Recall Campaign: 4877-1767, 8.1L Throttle Body

Gas engines 8.1

Product Safety Recall

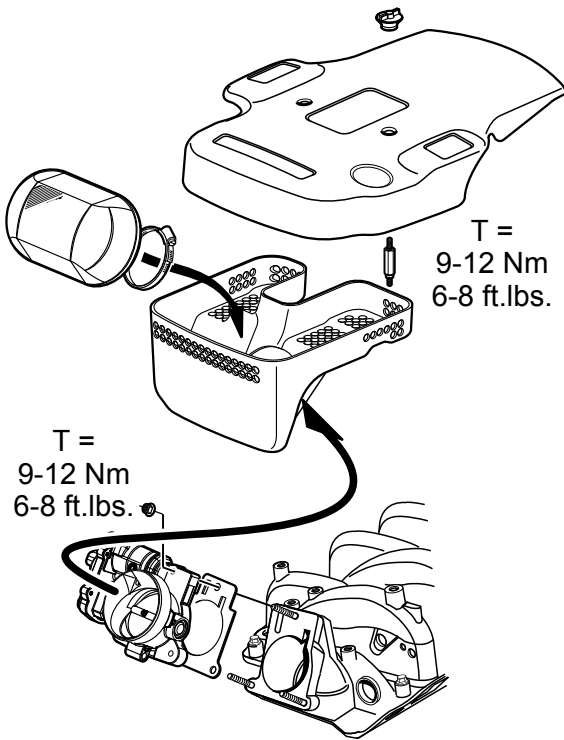
The campaign mark is two white paint dots on the throttle body. See illustration.

Inspect the throttle body for the campaign mark. If present file a warranty claim for the inspection, see below.

If no campaign mark is present the throttle body must be replaced.

Order the following part for each engine;
1 ea. 3817844, throttle body

Remove the existing throttle body;
disconnect engine battery power
remove the engine cover
loosen the clamp and remove the flame arrestor
remove the two studs, then the baffle, if present
disconnect the engine harness connector mounted to the throttle body; remove gray retainer, depress tang on the top of the connector, remove connector
remove the three nuts, then remove the throttle body

Reverse procedure for assembly of new throttle body.
Place the campaign marks on the new throttle body before installing baffle and cover.
